3 Volt Intel[®] Advanced+ Boot Block Flash Memory

28F800C3, 28F160C3, 28F320C3, 28F640C3

Specification Update

Order Number: 297938-014

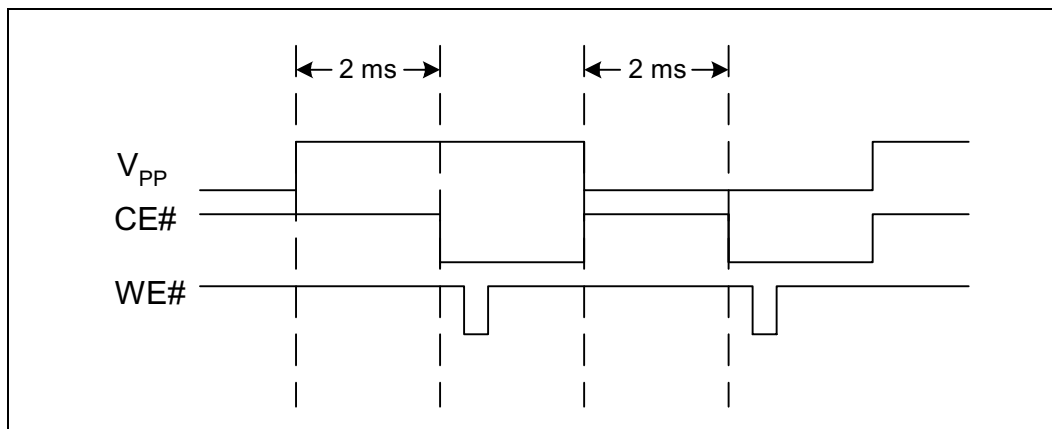
2. 28F320C3xC Reset Failure

Problem: The 0.18 μm 28F320C3xC devices can unintentionally reset under certain conditions where V_{PP} toggles.

Implication: When the reset occurs, any command being executed is interrupted and the flash switches to read array mode.

- 1) Tie V_{PP} to V_{CC} ;
- 2) If the third and forth digits on the top side FPO mark (third line) is equal or greater than “23”, then V_{CC} may be set from 2.7v to 3.3v. V_{CC} must not exceed 3.3v
- 3) Set V_{PP} to a static high or static low level as shown here; and

4) Wait 2 ms after a V_{PP} transition to access the flash device, as shown here.

Figure 1. Workaround Placement

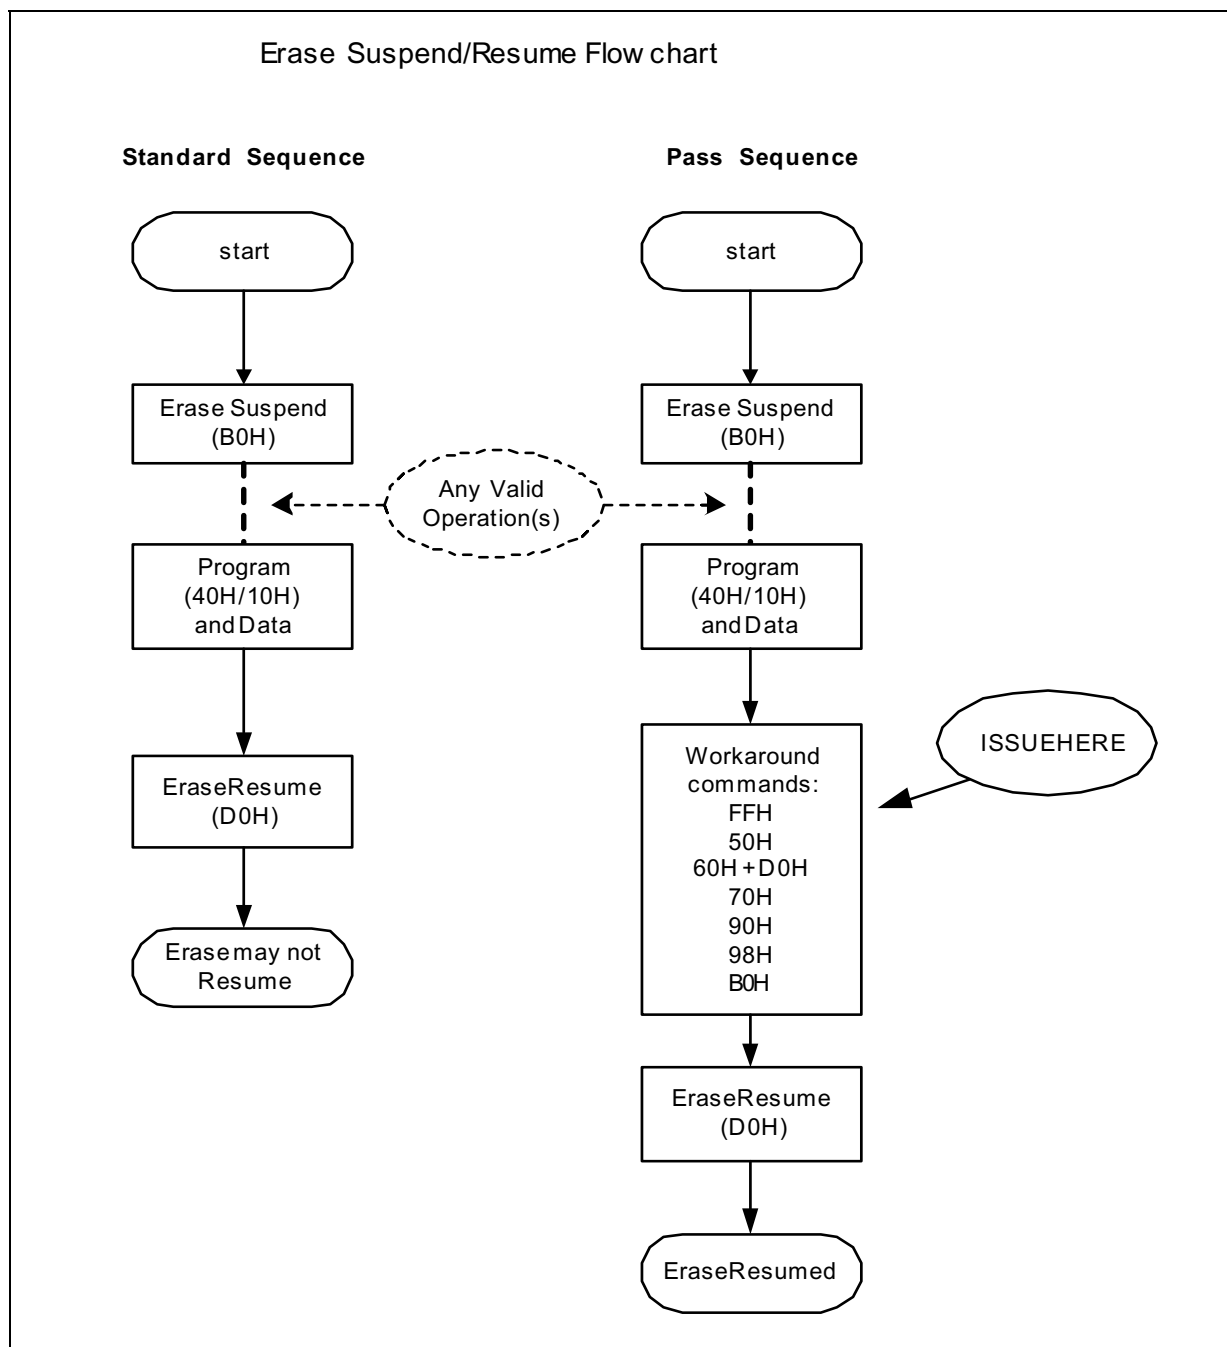
4. 28F160C3xC Erase Resume Issue

Problem: On the 0.18μm 28F160C3xC devices, a design anomaly was discovered. During an Erase-Suspend operation, if the Program (40H/10H) sequence is executed, under limited conditions the proceeding Erase Resume command (D0H) may not actually resume the device. No customers have reported failures in product applications. Customers who use any version of FDI (Intel Flash Data Integrator) software will not see this issue. If the Read Array command is issued prior to the Erase Resume command, users will not see the issue (typical in XIP applications).

Implication: The Resume Command (D0H) may be ignored by the device and will not correctly resume. The device will appear to remain in suspend (via status register). After a reset of the flash device the status register will clear. This failure has been recreated in a lab environment only.

1. If FDI (Intel Flash Data Integrator) software is used, users will not see the issue.
2. During an Erase-Suspend (B0H), user must issue any of the following commands after issuing the Program (40H/10H) and data sequence but before issuing the Erase-Resume (D0H) command.

5. 28F160C3xC and 28F640C3xC Lock/Unlock/Lock-Down Operation

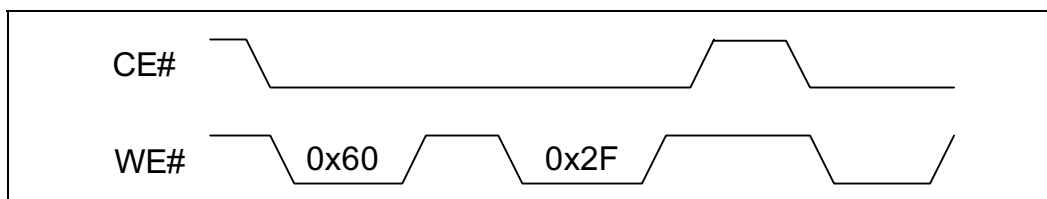
Problem: On the 16Mb and 64Mb 0.18µm devices, if CE# is deasserted after any block lock operation and before the next write sequence, the part may perform the same operation on additional blocks. (See waveform below.)

Implication: When CE# is deasserted after performing a block lock operation to a specific block and prior to the next write sequence, other blocks may perform the same operation.

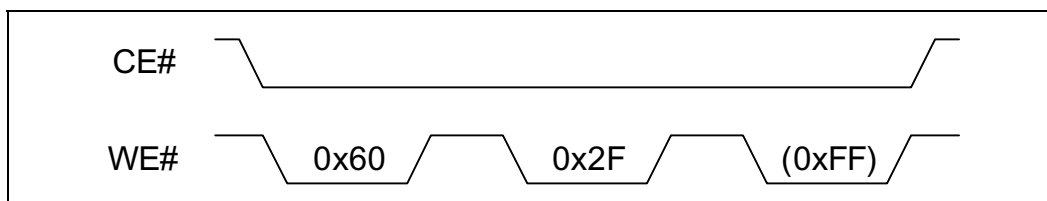
Workaround: Depending on software implementation, systems may already be effectively managing this erratum. There is currently a workaround for this erratum:

Immediately after performing a block lock, unlock, or lock-down operation, perform a valid write sequence before chip enable (CE#) is deasserted.

- 1) Assert CE# and toggle WE# to write the block lock setup command (0x60).
- 2) Toggle WE# a second time to write the confirm command (lock = 0x01; unlock = 0xD0; lock-down = 0x2F).
- 3) Toggle WE# a third time (ex: 0xFF- Read Array) before CE# is deasserted. (See waveform below.) Any other valid write sequence will also work (i.e., 0x90 - Read Configuration, 0x40 - Program, 0x20 - Erase).
